Preliminary Consultation
MONTGOMERY COUNTY HISTORIC PRESERVATION COMMISSION
STAFF REPORT

Address:	15114 Barnesville Road, Boyds	Meeting Date:	10/23/2024
Resource:	Primary (1850-1935) Resource Boyds Historic District	Report Date:	10/16/2024
Applicant:	SRK LLC Jesse Tarr, Agent	Public Notice:	10/9/2024
Review:	Preliminary Consultation	Tax Credit:	Partial
Proposal:	New ADA access, porch alterations, fenestration alterations and other work	Staff:	Laura DiPasquale

STAFF RECOMMENDATION

Staff recommends the applicant make any revisions recommended by the HPC and return for a HAWP or another preliminary consultation..

Figure 6: Front and side elevation drawings showing the proposed ramp.

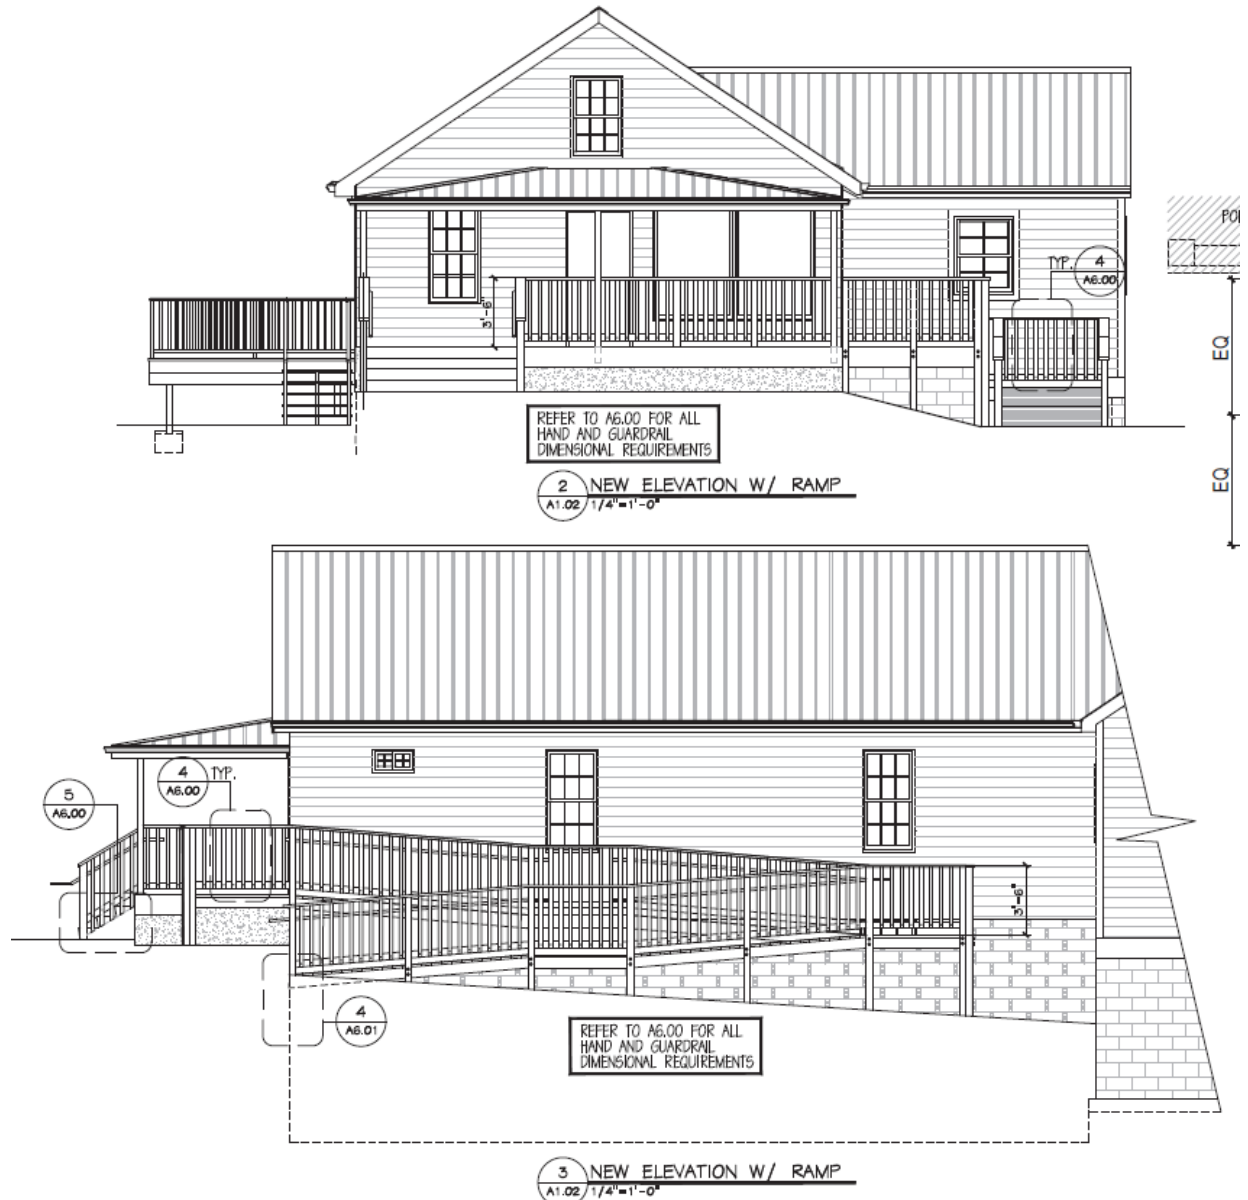
The applicants propose to install a switchback ADA ramp constructed of pressure treated wood along the west side elevation, leading to the front porch. The existing concrete porch floor would be built up with new wood supports, decking and fascia to accommodate for the change in elevation between the existing porch floor and interior floor height. A new pressure treated wood railing with vertical balusters is proposed around the perimeter of the porch, as well as along the ramp. Staff notes that early-twentieth century commercial buildings with porches did not typically feature porch railings, and recommends that any new railing introduced be as minimal as possible. Staff also finds that unpainted pressure treated lumber is generally not a compatible material for use on a Primary resource, and recommends that the applicants use painted wood installed in a historically appropriate method for all porch alterations, including decking, railings, posts, fascia, and steps, in keeping with the HPC's *Policy No. 24-01* and Chapter 24A-8(b)(2). The applicants should submit samples and details of the proposed porch flooring and railings for the HAWP.
